Service Update

SU 2302 7.3L RADIATOR COOLANT LEAKS

Models Affected: Model Year 2021 thru current model BBCV buses equipped with Ford 7.3L engine.

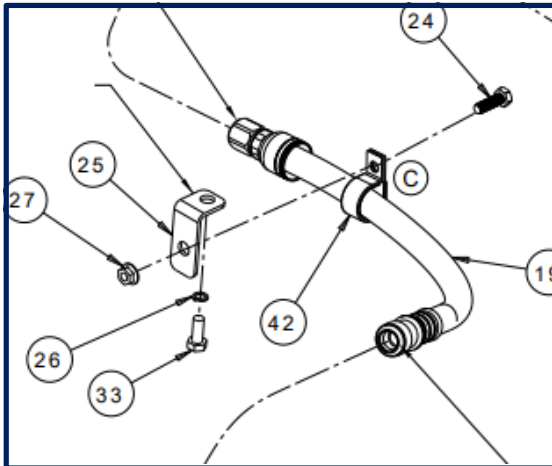
- 13) Remove pipe nipple, apply Loc-Tite™567 to NPT threads, and Install 10081789 90° fitting into the left/driver's side cooler port. Clock fitting as shown below.

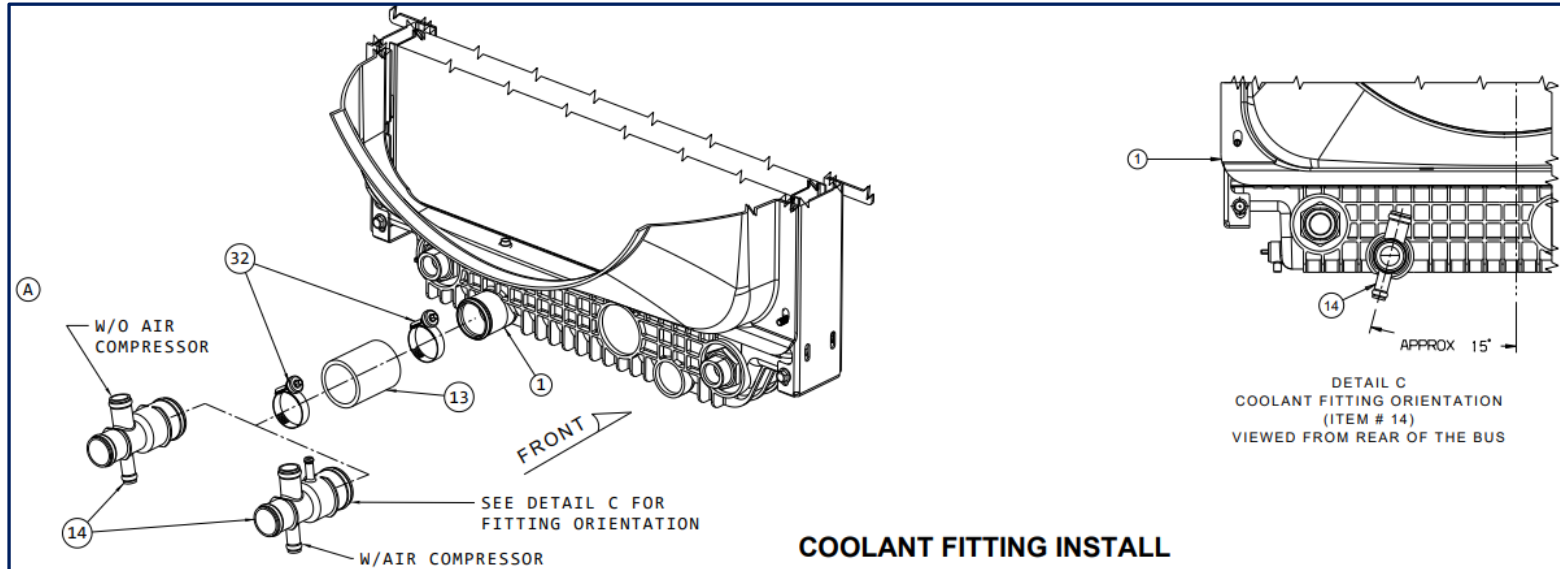
15) Verify P clamp from passenger side cooler line is configured, per the below illustration. Make corrections if not.
